**Subject: Work Plan Addendum for Additional Site Investigation  
FV Steel and Wire Company Site  
111 North Douglas Street, Hortonville, Wisconsin  
BRRTS No. 02-45-560221  
AECOM Project No. 60428891**

Addendum to the Work Plan for Additional Site Investigation  
FV Steel and Wire Company Site, 111 N. Douglas St., Hortonville, Wisconsin

### CROSS SECTION A A'

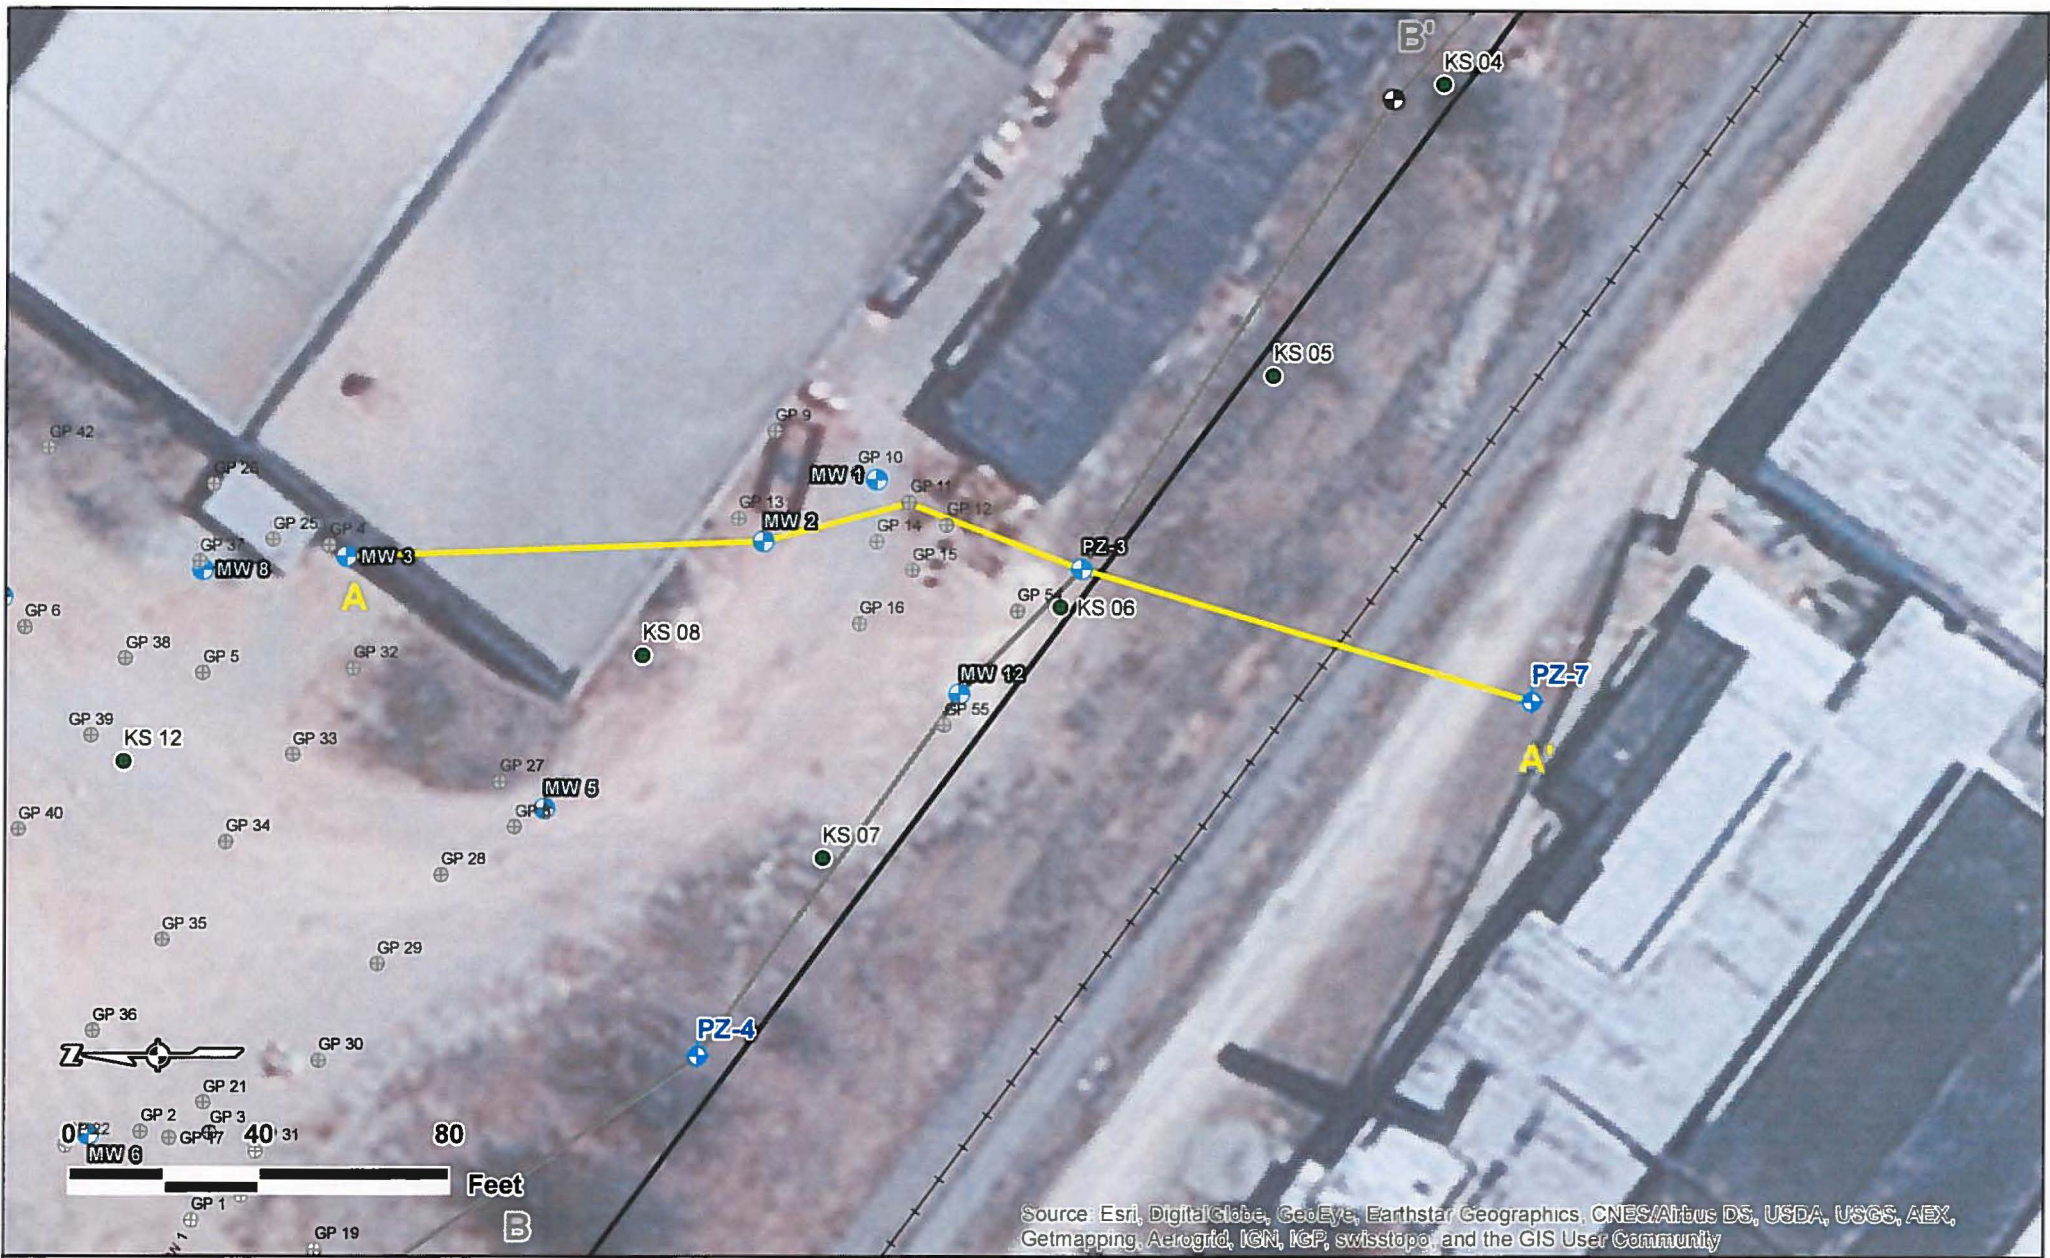
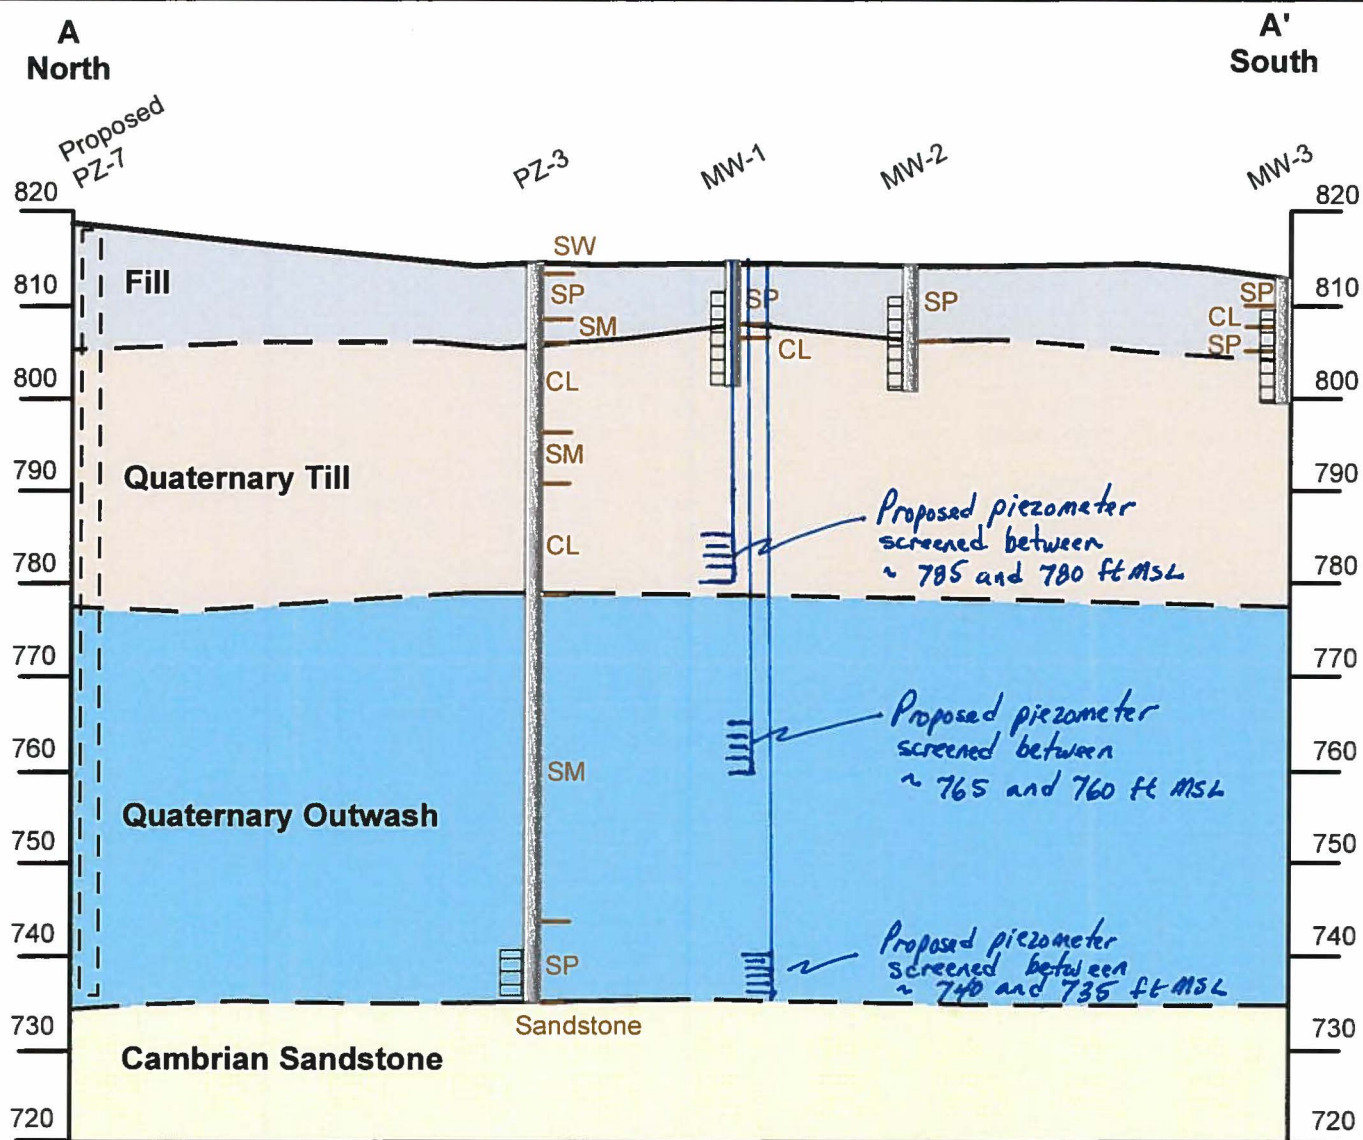
*Add a well nest adjacent to MW-1*

- one 25-foot piezometer with 5-foot screen*
- one 45-foot piezometer with 5-foot screen*
- one 70-foot piezometer with 5-foot screen*
